06/02/18- Objection to: 17/05234/FUL - Erection of 17No. residential dwellings to include new access road and associated parking

Tree Protection Plan TS07 - 002 rev01 (January 2018) contained within the arboricultural report maps the RPA of T1 as a circle. See extract below.

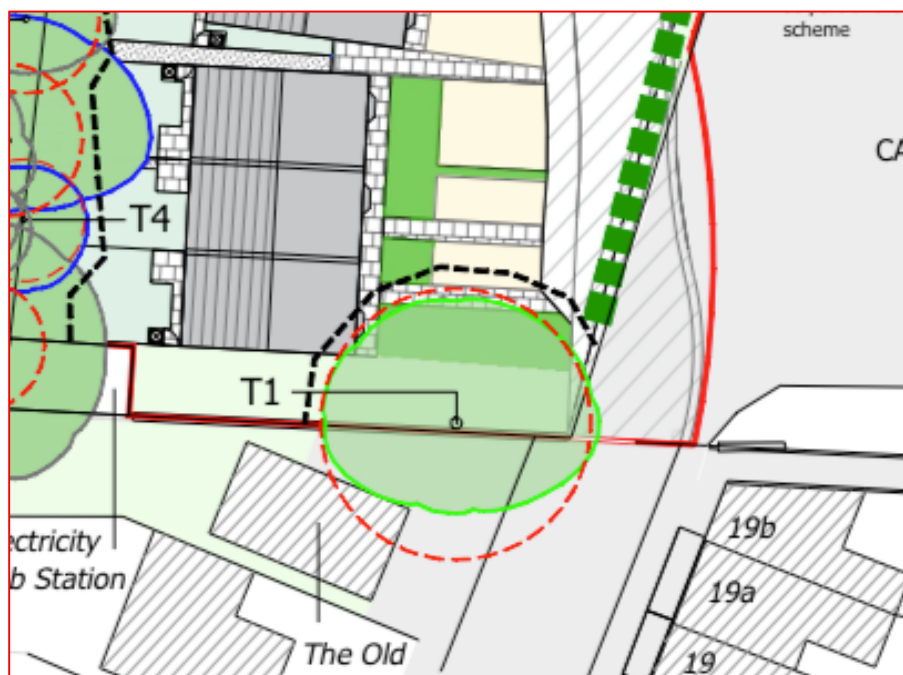
This circular RPA is clearly incorrect as rooting is inhibited to the south and east due to the presence of hard standing, a wall and previous construction activity, i.e. a house. The photographs below illustrate this.

The circular RPA attributed to T1 does not reflect the area where roots are most likely to be distributed therefore this should be revised or the tree will be harmed.

T1 lime (actual) root protection area (shown in blue). A circular RPA is not appropriate. The blue box above should remain free of all construction activity.

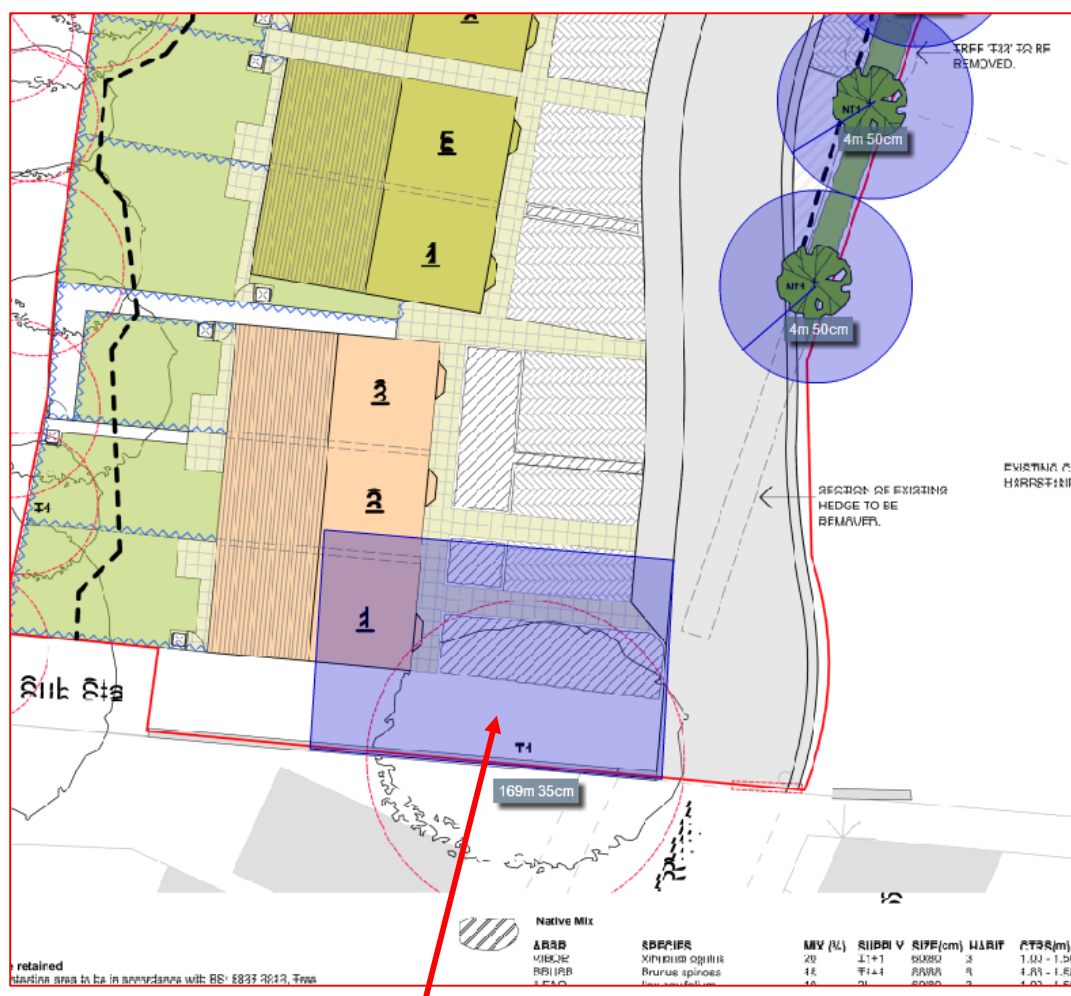
A blue box representing the (actual) root protection area of this tree is shown below. The ground highlighted is the most likely area where tree roots will be found as it is soft and undisturbed. The box covers an area of 169m<sup>2</sup>. This is less than the minimum 174m<sup>2</sup> recommended for this tree in BS5837 and the tree report, but it illustrates the approximate area needed to protect its roots.

It is shown below using a box shape as rooting is restricted to the south and east due to the presence of hard standing and previous construction activity. Even if the shape of the RPA is slightly altered, plot 1 will still encroach. Put simply, plot 1 must be moved out of the blue box shown below or this protected tree will be harmed as a direct result of this development.
